**UNITED STATES
NUCLEAR REGULATORY COMMISSION**
WASHINGTON, D.C. 20555-0001

**SUBJECT: NINE MILE POINT NUCLEAR STATION, UNIT NOS. 1 AND 2 - ISSUANCE OF
AMENDMENTS RE: REVISIONS TO THE TECHNICAL SPECIFICATIONS
DESIGN FEATURES SECTIONS TO REFLECT THE TRANSFER OF A
PORTION OF THE NINE MILE POINT NUCLEAR STATION SITE REAL
PROPERTY (TAC NO. ME6783 AND ME6784)**

SAFETY EVALUATION BY THE OFFICE OF NUCLEAR REACTOR REGULATION
RELATED TO AMENDMENTS NOS. 212 AND 142 TO RENEWED FACILITY OPERATING
LICENSE NOS. DPR-63 AND NPF-69
NINE MILE POINT NUCLEAR STATION, LLC
NINE MILE POINT NUCLEAR STATION, UNIT NOS. 1 AND 2
DOCKET NOS. 50-220 AND 50-410

FIGURE 5.1-1
SITE BOUNDARIES
NINE MILE POINT - UNIT 1

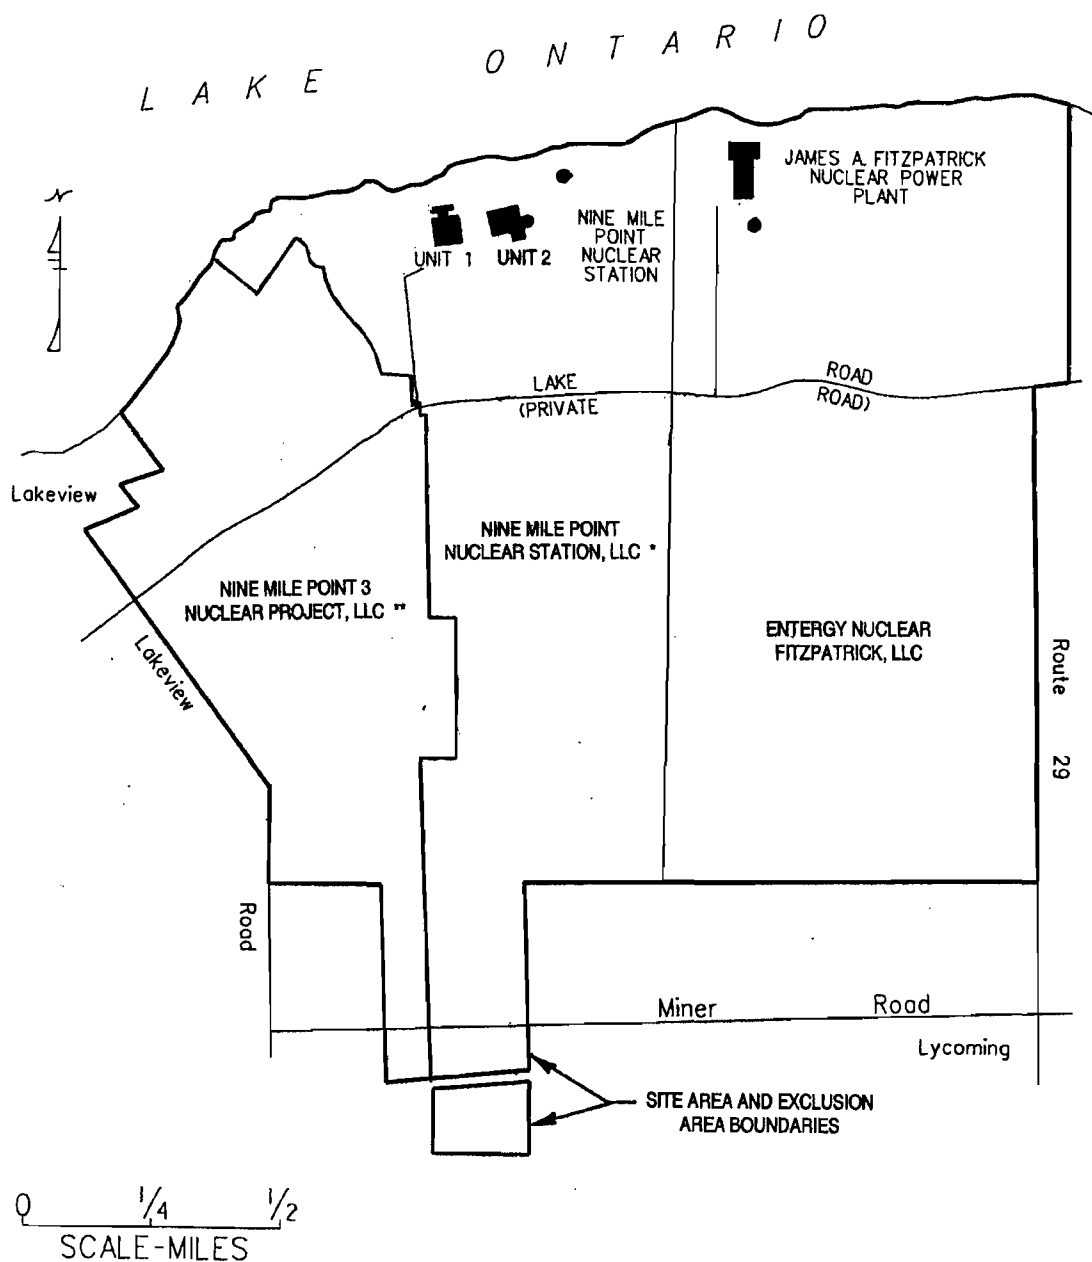
The amendments revised the NMP1 Technical Specification (TS) Section 5.1, "Site," and associated TS Figure 5.1-1, "Site Boundaries, Nine Mile Point - Unit 1," and the NMP2 TS Figure 4.1-1, "Site Area and Land Portion of Exclusion Area Boundaries," to reflect the transfer of a portion of the Nine Mile Point Nuclear Station, LLC (NMPNS) site real property located outside of the NMPNS Protected Area but within the current NMPNS Owner Controlled Area, as well as specified easements over the remainder of the NMPNS site, to Nine Mile Point 3 Nuclear Project, LLC (NMP3), a subsidiary of UniStar Nuclear Energy, LLC.

The primary change is to revise NMP1 TS Figure 5.1-1, "Site Boundaries, Nine Mile Point – Unit 1," and NMP2 TS Figure 4.1-1, "Site Area and Land Portion of Exclusion Area Boundaries," to reflect the transfer of a portion of the existing NMPNS site real property located outside of the NMPNS Protected Area but within the current NMPNS Owner Controlled Area to NMP3. On both of these figures, a new boundary line and associated label are applied to identify the portion of the NMPNS site that will be conveyed to NMP3, the COL applicant. In addition, the following footnote applicable to the property owned by NMP3 Nuclear Project, LLC is added to both figures:

The site area boundary and exclusion area boundary are as shown in Figure 5.1-1.

** Nine Mile Point Nuclear Station, LLC has easements to access and use the property owned by Nine Mile Point 3 Nuclear Project, LLC for security, emergency preparedness, and site monitoring purposes, by Agreement.

Nine Mile Point Nuclear Station, LLC has easements to access and use the property owned by Nine Mile Point 3 Nuclear Project, LLC for security, emergency preparedness, and site monitoring purposes, by Agreement.
